13-UP-2018
03/12/2019

RE: BLK Live Conditional Use Permit - City Comment Response Letter
CUP #: (12-UP-2018)

DELTA 2 – CUP City Comment Responses

UP 1

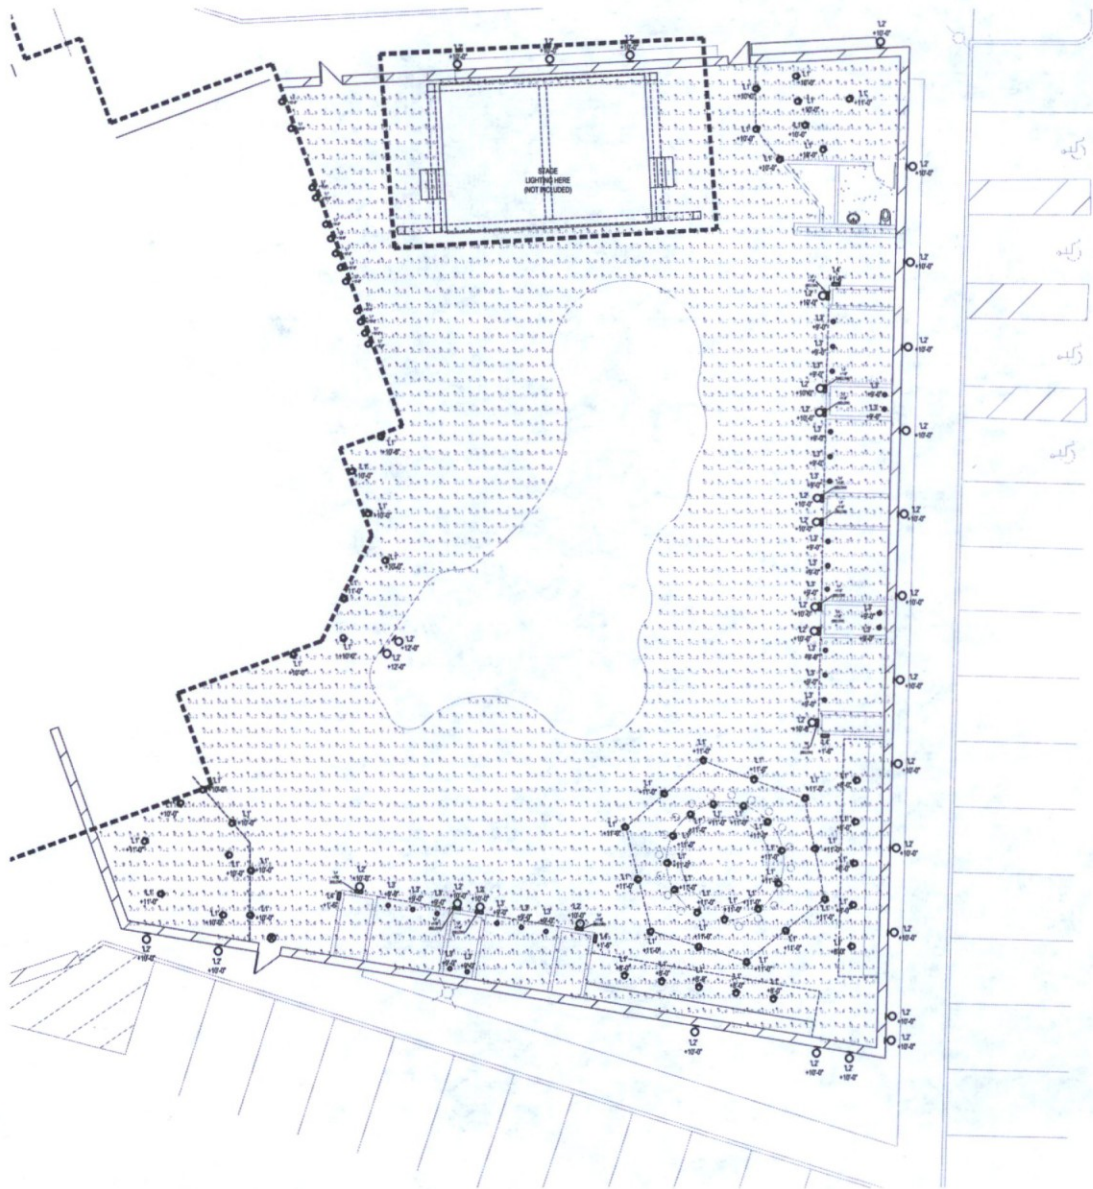
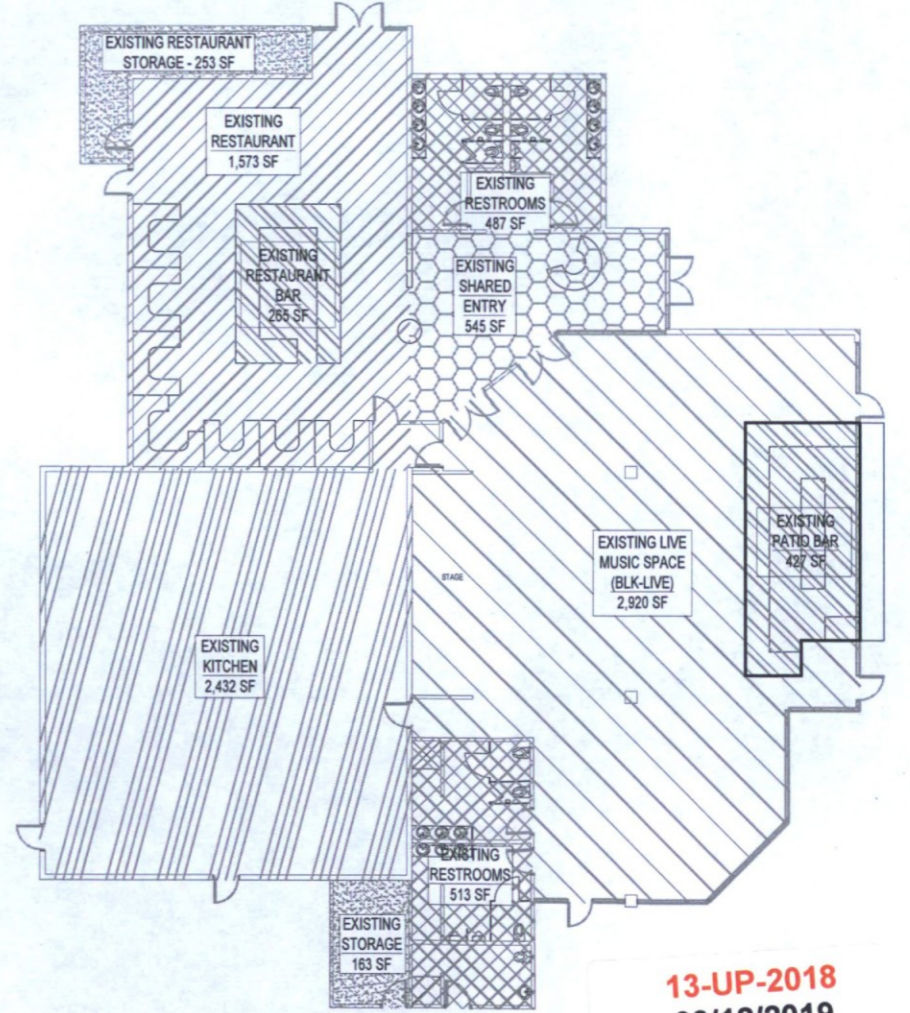
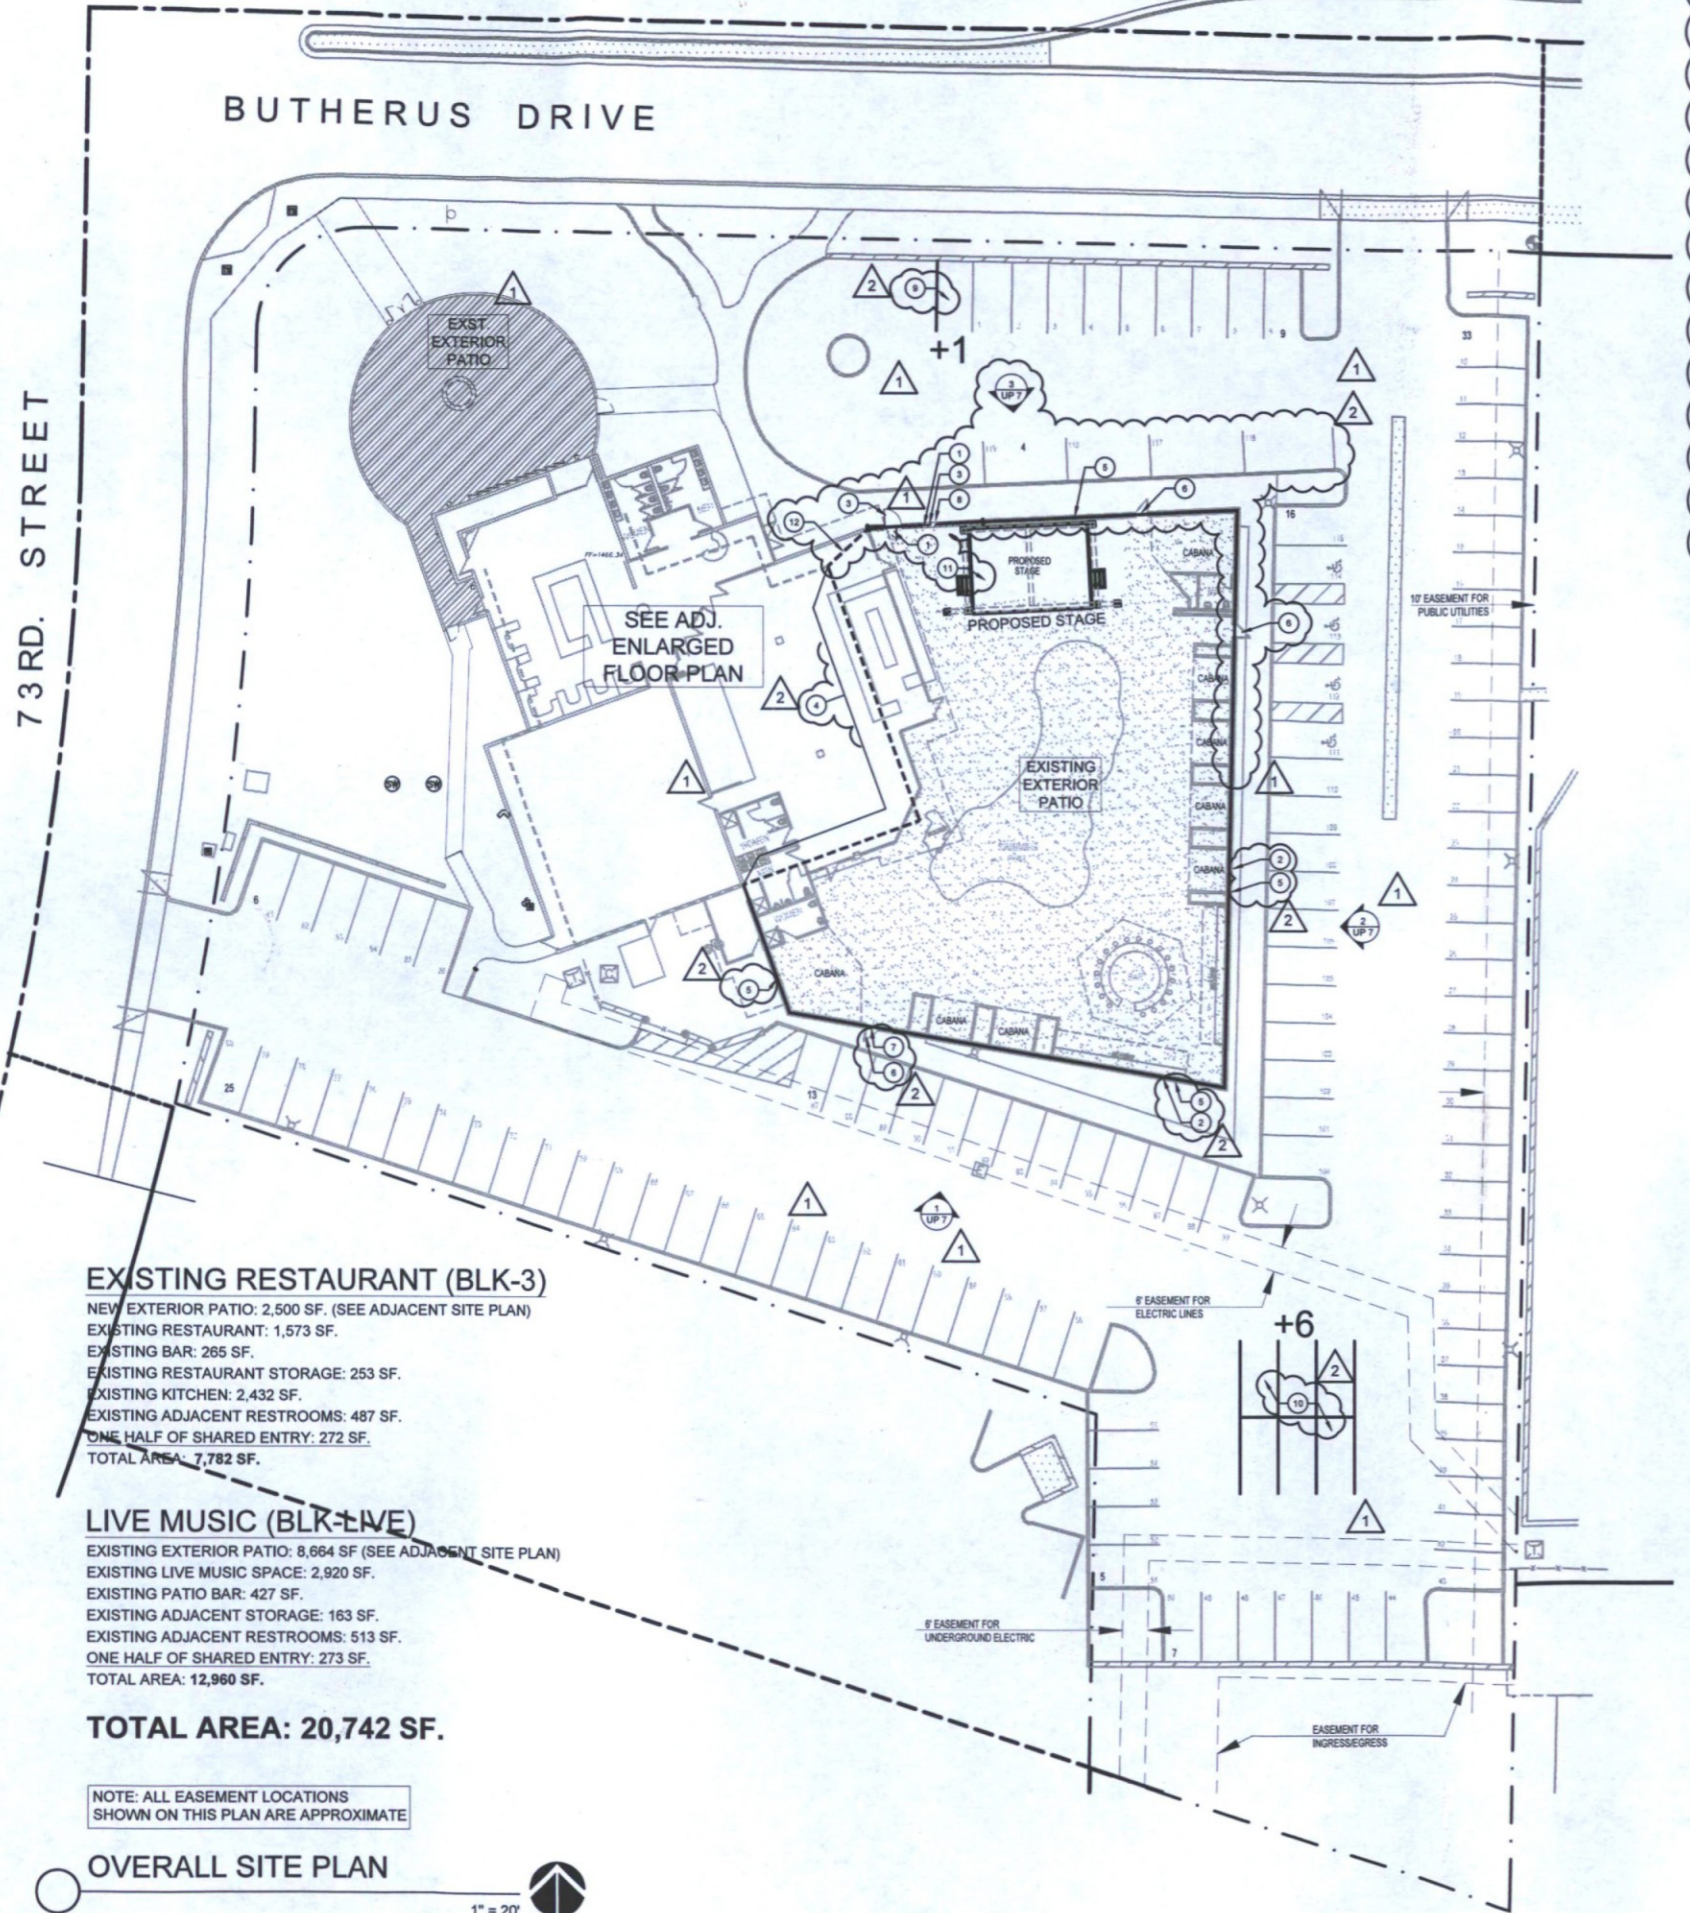
- 1) Parking quantity achieved. See revised parking parking calculations for all owned and leased stalls, quantities, and addresses. A total quantity of (138) stalls was deemed acceptable by Bryan Cluff , via email, on Tuesday, October 30th. See sheet (UP 7) for all locations on a map and distances between property lines.

- 2) The acoustical canopy is now shown going around the entire patio, along those sections of existing mechanical screen adjacent to the patio, and a short mechanical screen extension on the roof in the northwest corner of the patio per **citizen comment #9**.

- 3) To make this sheet easier to read I added site plan keynotes and removed the notes directly on the plan. Some new keynotes were added.
- 4) The new (8) angeled stalls have been removed per **city comment #2**. Not changes to the (4) existing stalls here. Instead those (8) stalls have been leased from an adjacent property.

UP 7

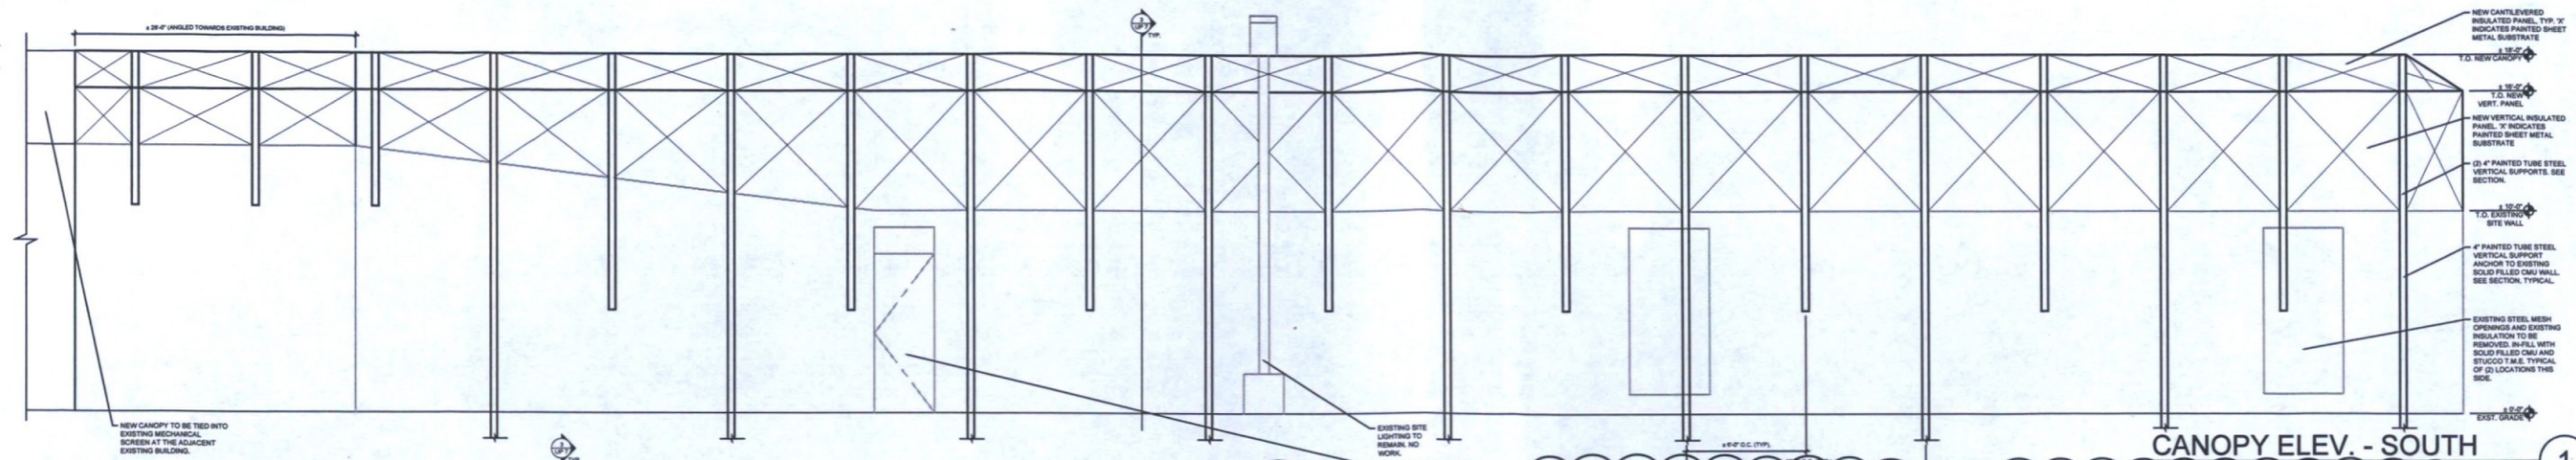
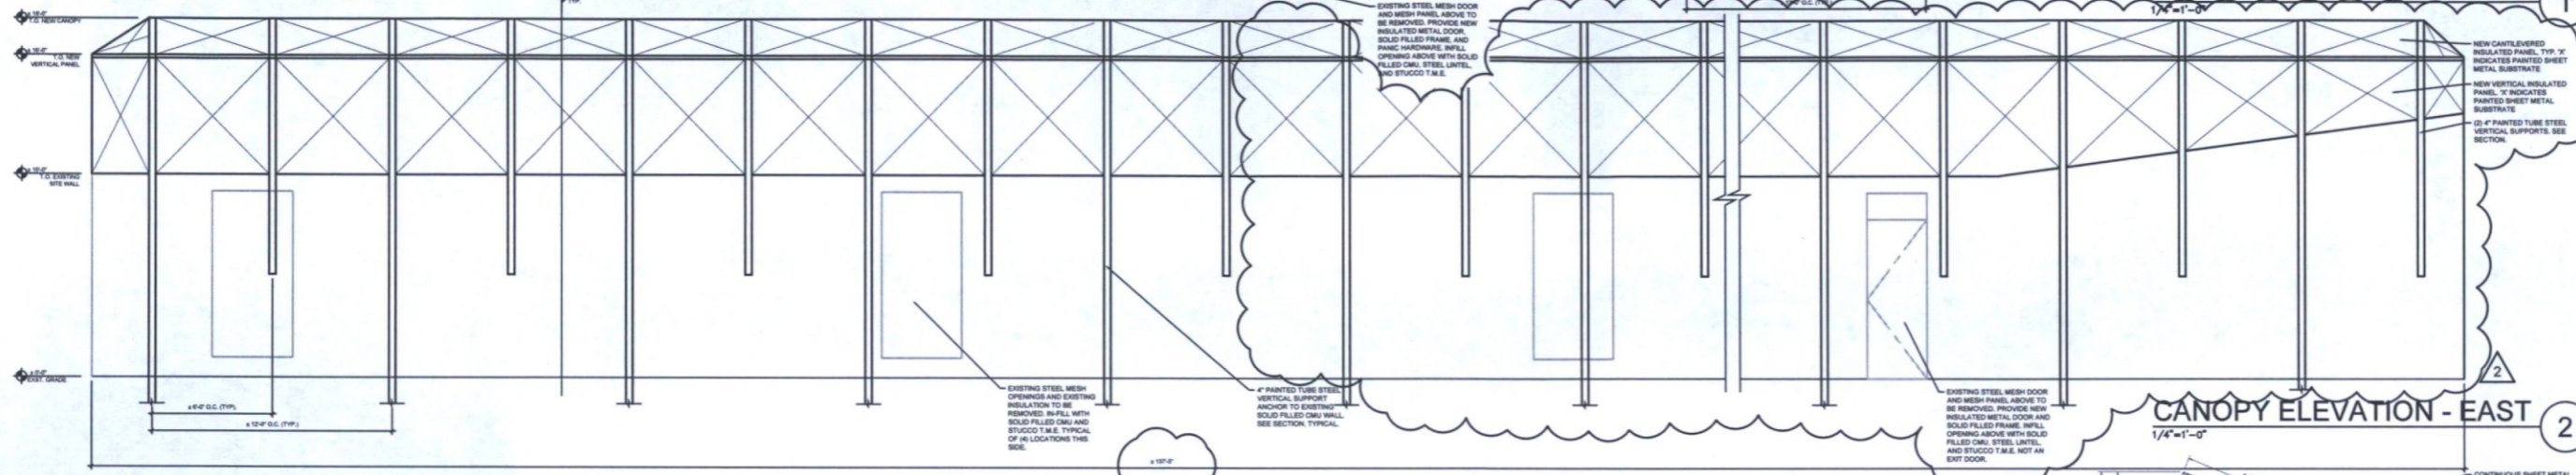
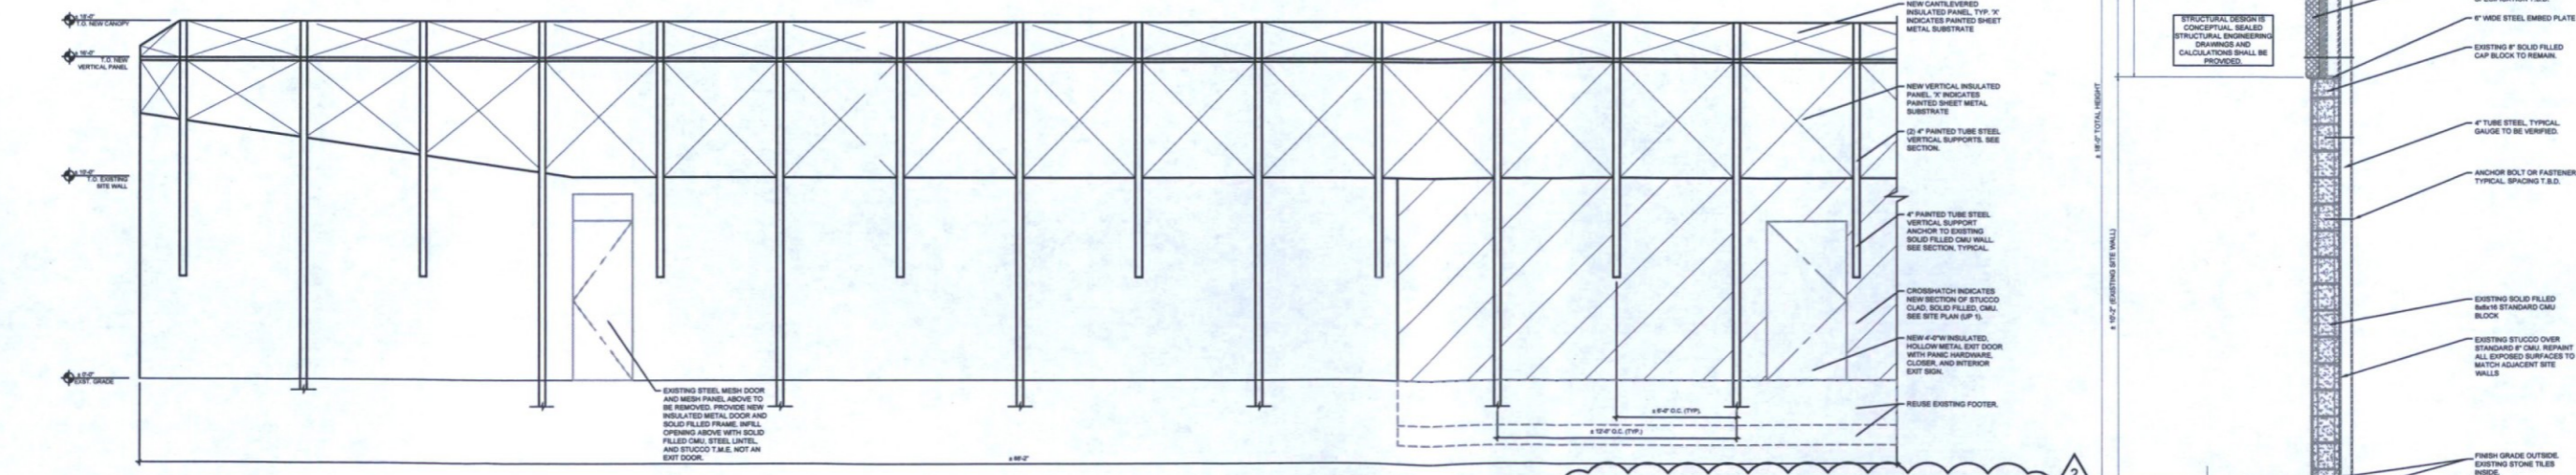
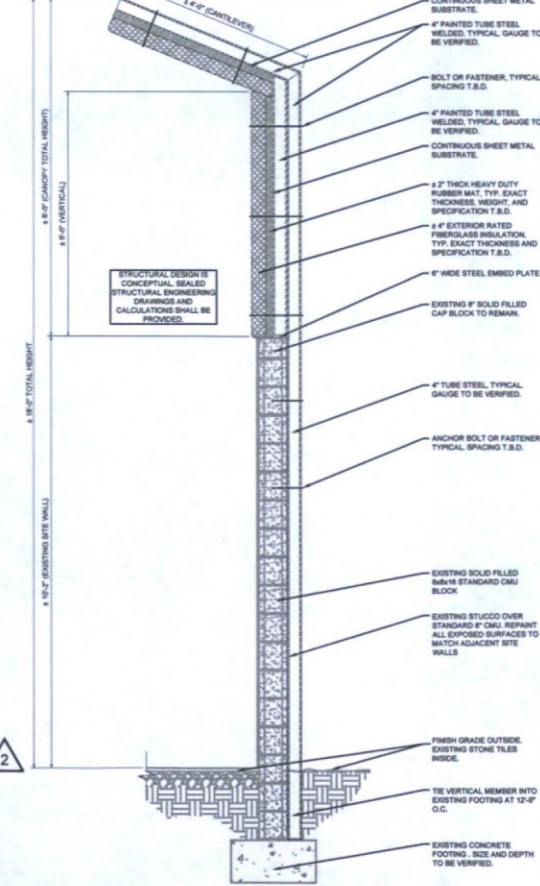
- 1) This elevation #2 has been revised to show the acoustical canopy extended on the north/south perimeter wall to the northeast corner. Elevation #4 has been added to show some walls changes and acoustical canopy above the entire north wall as referred to in citizen comment #9. The patio is now completely surround with acoustical canopy.
